Project	<b>IEEE 802.16 Broadband Wireless Access Working Group</b> < <a href="http://ieee802.org/16">http://ieee802.org/16</a> >	
Title	<b>Recirculation Letter Ballot 13a Comment 520 Reply</b>	
Date Submitted	<b>2004-01-08]</b>	
Source(s)	Robert Nelson MacPhy Technologies 1104 Pittsburgh Landing Richardson, TX 75080	Voice: 972-239-9224 Fax: 972-671-1455 bob_nelson@ieee.org
Re:	Letter Ballot 13a on document <b>IEEE P802.16-REVd/D2-2003</b>	
Abstract	Discussion and suggested resolution to recirculation ballot 13a comment 520	
Purpose	Reply comment for comment 520 in LB13a comment database	
Notice	This document has been prepared to assist IEEE 802.16. It is offered as a basis for discussion and is not binding on the contributing individual(s) or organization(s). The material in this document is subject to change in form and content after further study. The contributor(s) reserve(s) the right to add, amend or withdraw material contained herein.

## Letter Ballot #13a

### Comment 520 Reply

**Figure 34—ARQ transmit block states**

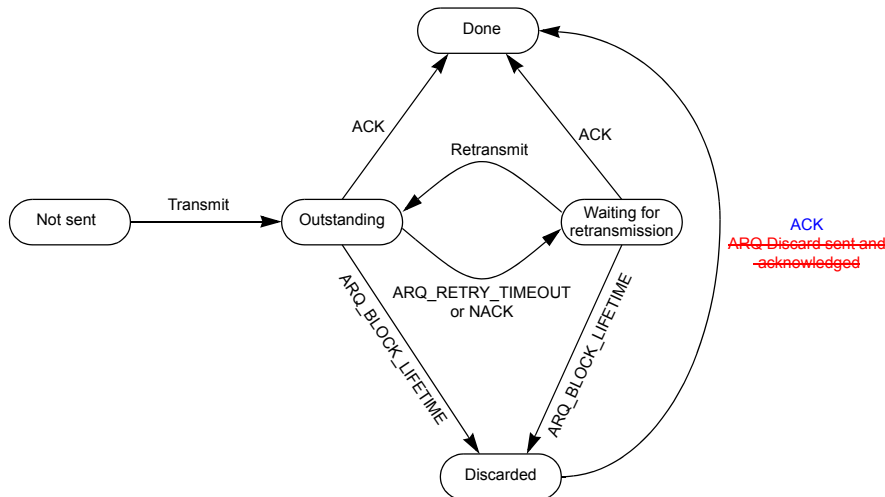
**Tranmit Block State Diagram**

Accept suggested change. However, an error occurred during transcription of the diagram. The following figure includes the suggested change without the transcription error.

Page 132, Line 3: Replace Figure 34 with the following:

Figure 37—ARQ block reception

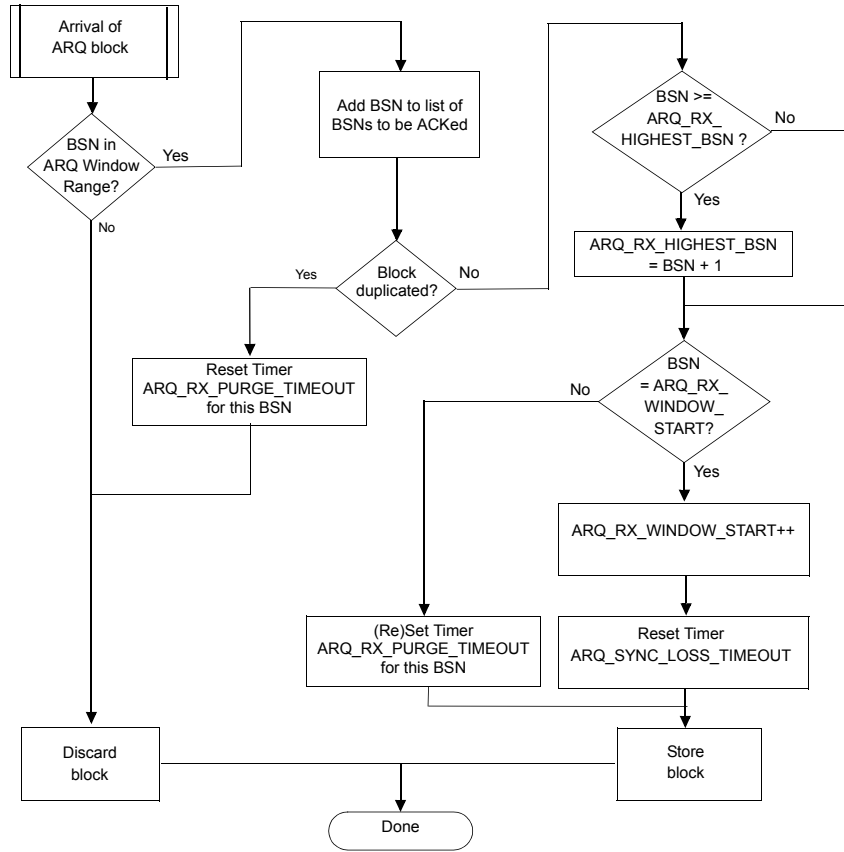
***ARQ Block Reception Diagram***

Assertions are made that there are problems with Figure 34 that are corrected by the submission:

The first issue is essentially that handling of *ARQ\_RX\_HIGHEST\_BSN* is not included in the figure. This is correct, the current diagram does not present the appropriate logic for updating this value.

The second issue concerns the fact that the figure does not support the case of updating window start by more than 1. The fact that this possibility is not supported is appropriate. The figure depicts reception processing on a block-by-block basis. Since it is required that BSN information be included in the feedback IE in time precedence order (oldest to newest), the window start value can only change by a value of one.

Finally, an enhancement is proposed concerning handling of duplicate blocks.

The enhancement appears to be to short-circuit processing if a duplicate is detected and only take one action (resetting the purge timer for the block). This change is incorrect. Doing so results in no stimulus being provided to the receiver to initiate transmission of feedback ACK information. The fact that a duplicate was received indicates that a previous ACK transmission was lost, and the transmitter requires a new feedback IE transmission. Implementing the suggested logic suppresses possibly the only stimulus that could result in that transmission, potentially causing the state machine to lock-up.

The following diagram implements logic for managing for *ARQ\_RX\_HIGHEST\_BSN*, and appropriate handling on duplicate blocks, but does not include the additions to handle window deltas greater than 1.

**|** *Page 135, Line 13: Replace Figure 34 with the following:*
